**Report Type:** DA Access Report  
**Reference Number:** 20120  
**Client:** Ashbury FMBM Pty Ltd  
**Site Address:** 149-163 Milton Street, Ashbury NSW

# ACCESS REPORT

This Access Compliance Report is to accompany a Development Application for the development proposed at 149- 163 Milton Street, Ashbury NSW.

[Image description: Plan of the common Basement above shows the provision of Accessible parking spaces]

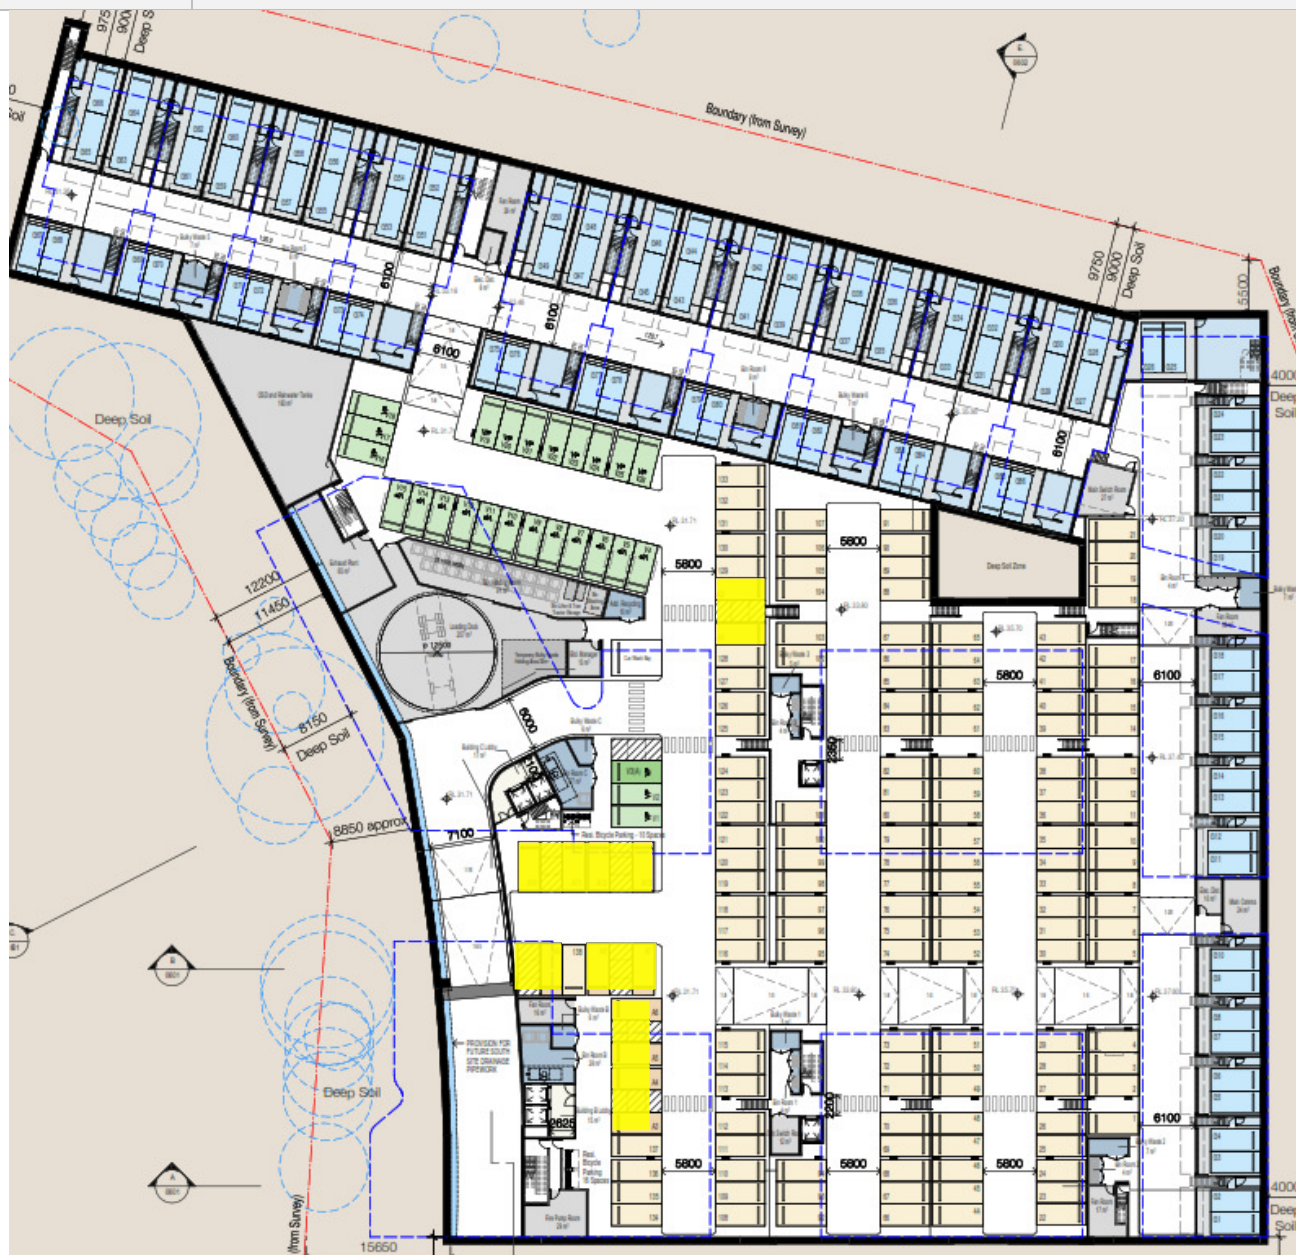
<b>BCA Part D3.5 Accessible Carparking</b>
<b>Requirement</b>	<b>Class 2</b> There are no Accessible carparking requirements for a Class 2 under the BCA. If adaptable housing has been mandated by the Council, then carparking spaces for Adaptable units will be required under the requirements of AS4299- Adaptable housing.
<b>Compliance Comments</b>	Capable of compliance Canterbury Bankstown Council requires provision of 10% Adaptable units in the development. Development has total number of 129 units. 10% of 129 = 13 required Adaptable units. Therefore, 13 accessible carparking spaces are required for the residential component of the development. 13 Accessible car parking spaces have been provided in development. One accessible parking space is required to be allocated to each of the Adaptable units. Note: all the adaptable units are located to Building B and C and therefore all the accessible parking spaces are provided to the Basement to access to the lifts to Building B and Building C.

**Type 1 - Pre-Adapted**

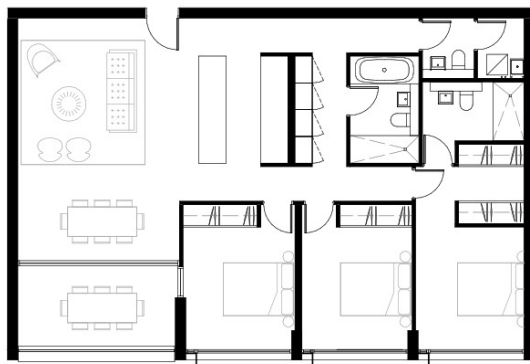
At DA stage there is insufficient information to certify compliance with the Standard, however, in accordance with the table below, the nominated units can comply with the spatial requirements of AS4299 for Adaptable Housing.

**Type 2 - Pre-Adapted**

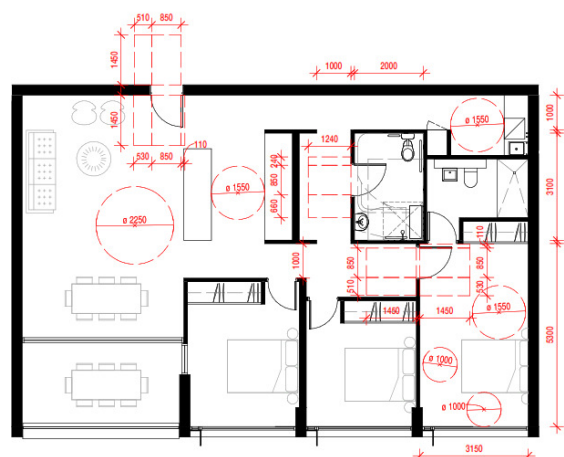
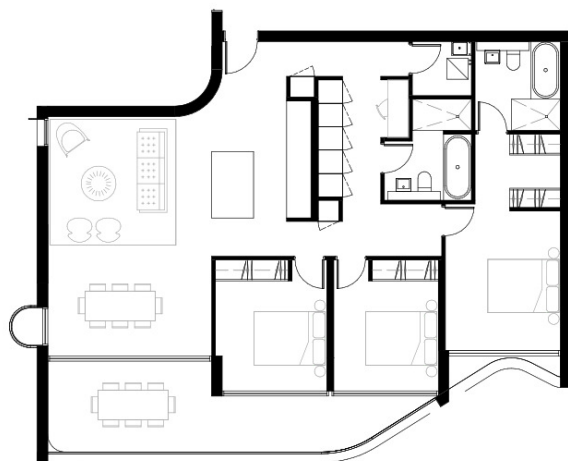
C.1.03, C.2.03, C.2.07, C.3.03, C.3.05, C.4.03, C.4.05

**Type 3 Pre-Adapted**

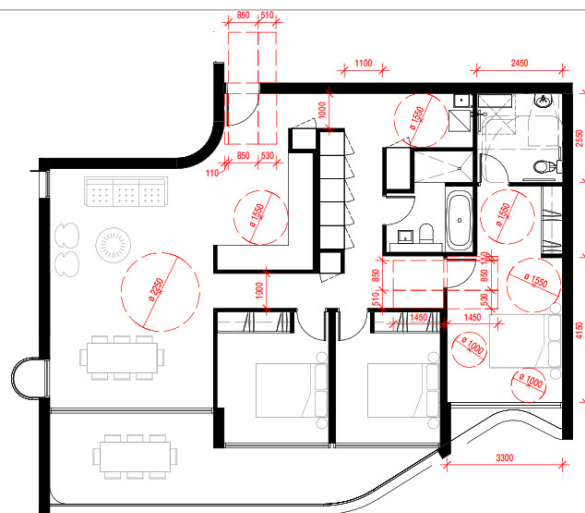
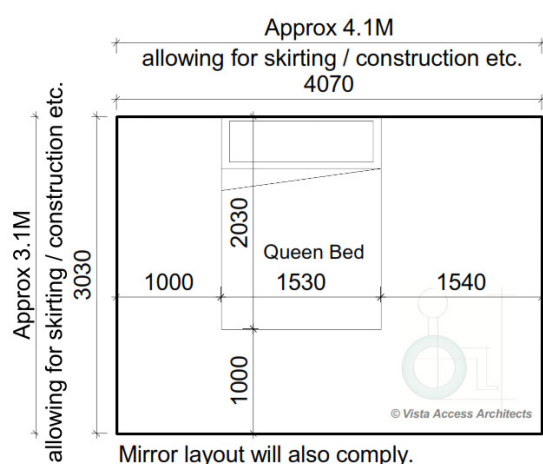
C.2.08, C.3.06
